AIP  
Supplement  
02/26  
Published on  
02 JAN 2026

### S02 Kigoma Airport – HTKA

Kigoma Airport (HTKA) is undergoing Apron rehabilitation commenced on 1<sup>st</sup> September 2025 and expected to be completed on 28<sup>th</sup> February 2026, the work is focusing on the expansion of the apron and closure of taxiways to improve airside infrastructure.

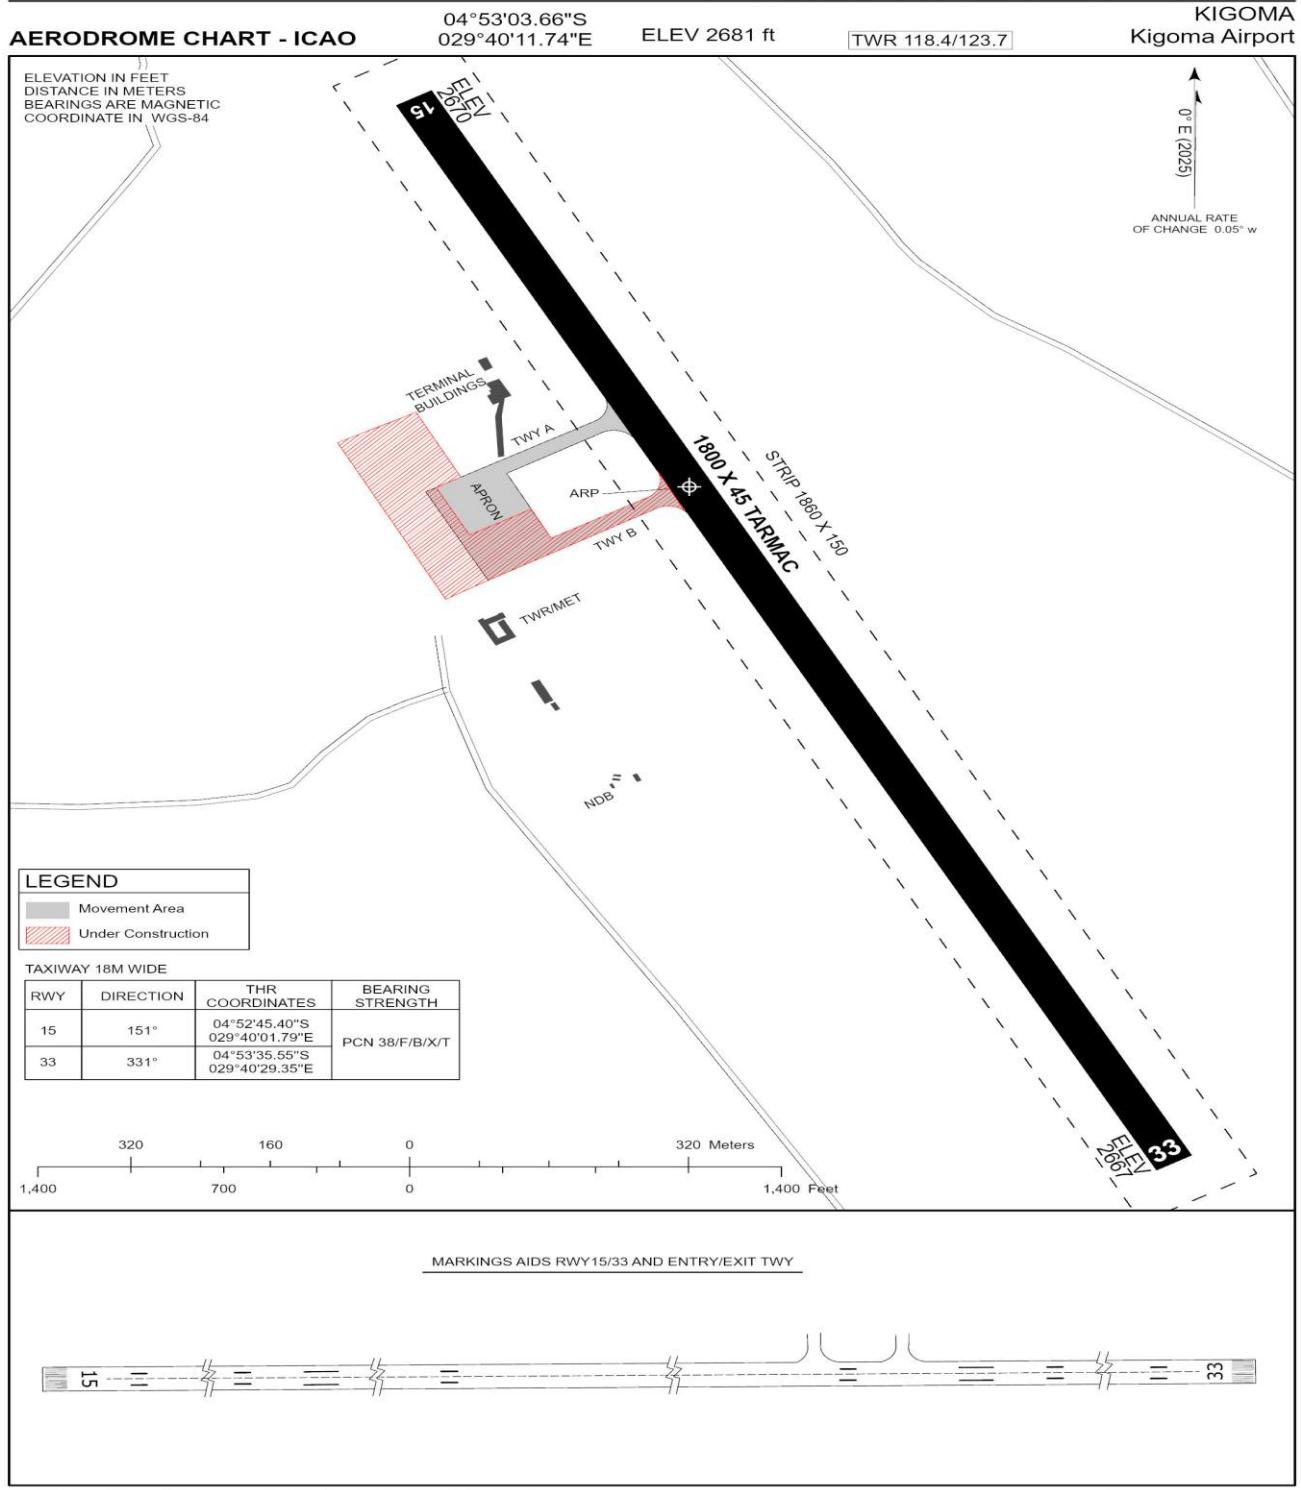
#### Phase 2: From 2 January 2026 to 28 February 2026

- Taxiway Status:  
Taxiway A (TWY A) will be closed.  
Taxiway B (TWY B) will be opened and operational.
- Finalization of Apron Works:  
Continued finishing work including marking and signage updates
